**DEVIATION REQUEST** (Attach diagrams, figures, and other documentation to clarify request)

A deviation from the standards of or in Section **2.3.8.A** of the Engineering Criteria Manual (ECM) is requested. The request is to allow a proposed non-through road to provide access to the lots in this proposed subdivision with a length of 2120 feet. Please refer to the attached exhibit.

# EAGLE RISING FILING NO. 1

EAGLE RISING FILING NO. 1  
FINAL PLAT  
JOB NO. 43-043  
DATE PREPARED: 06/30/2022  
DATE REVISED:

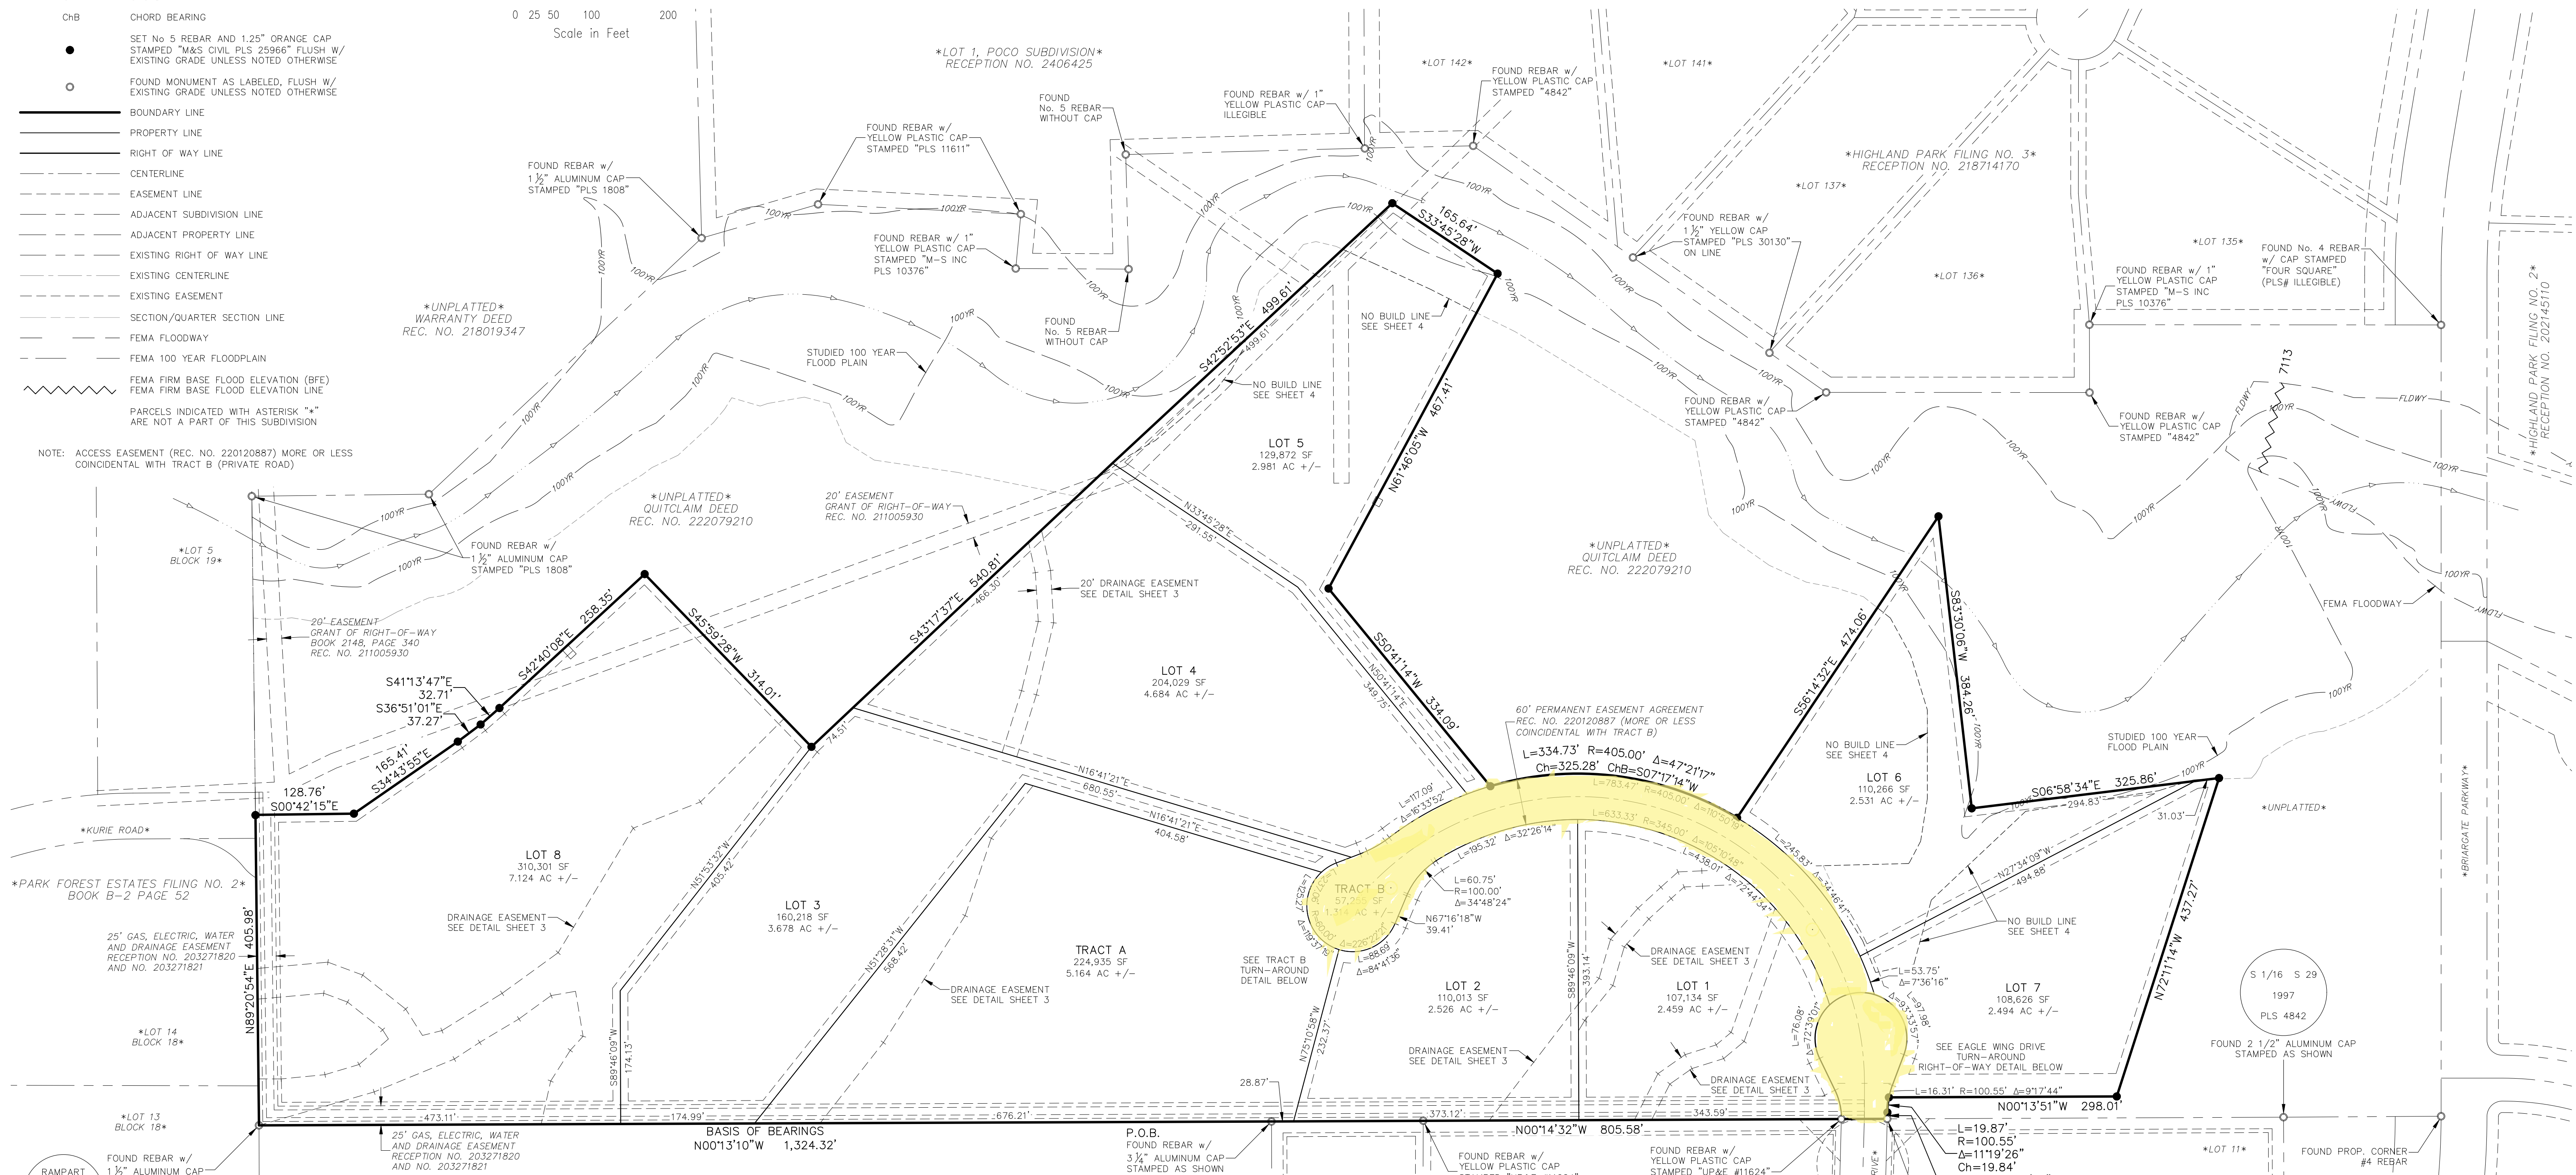
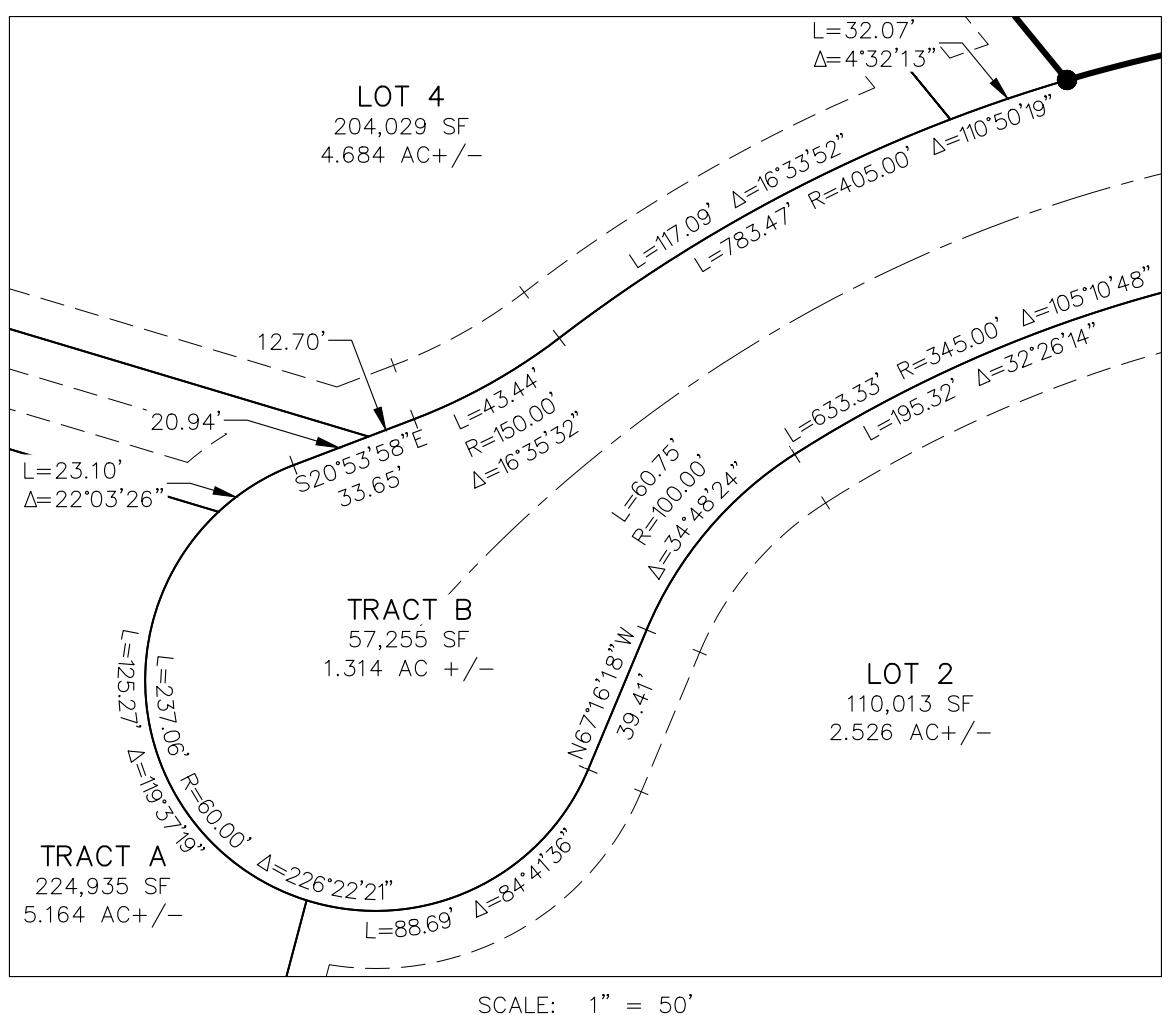
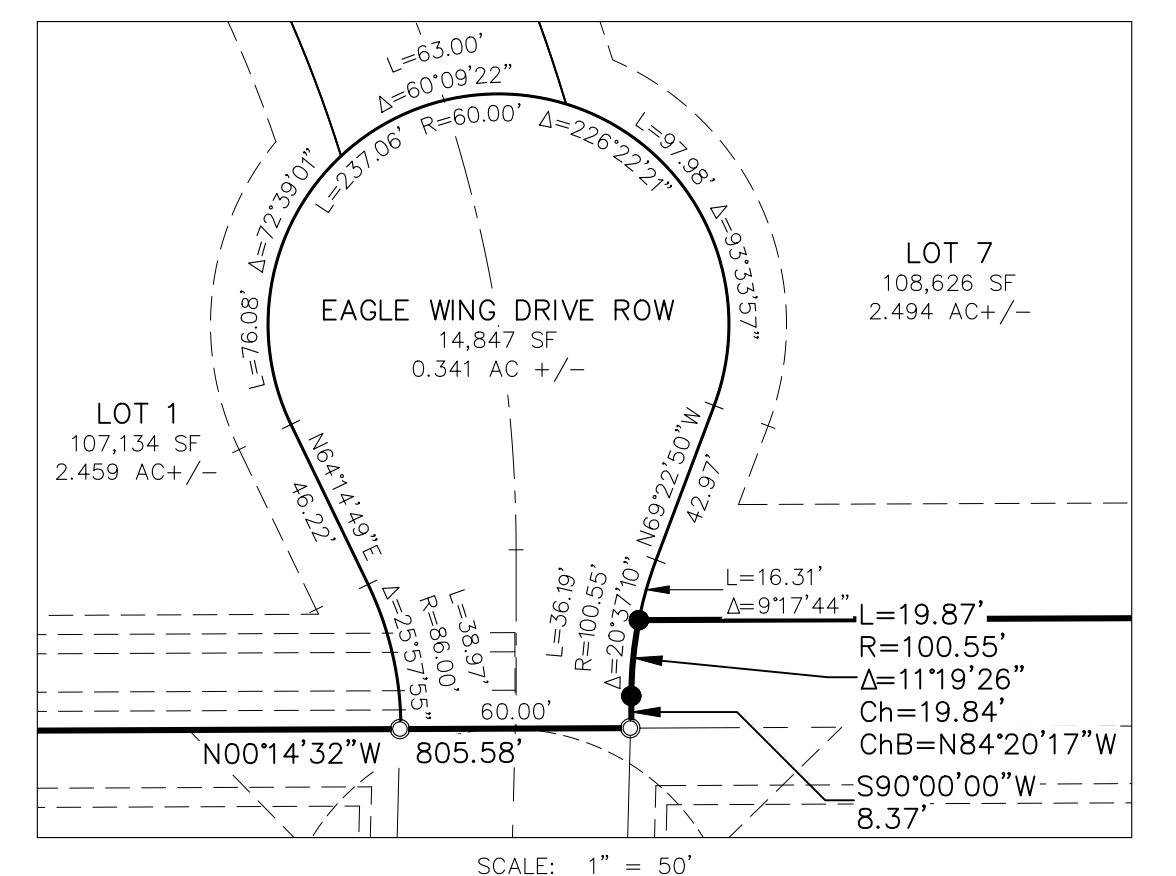
This should state 7 lots and one tract will access the proposed cul-de-sac. Lot 8 is proposed to access from Kuri Road
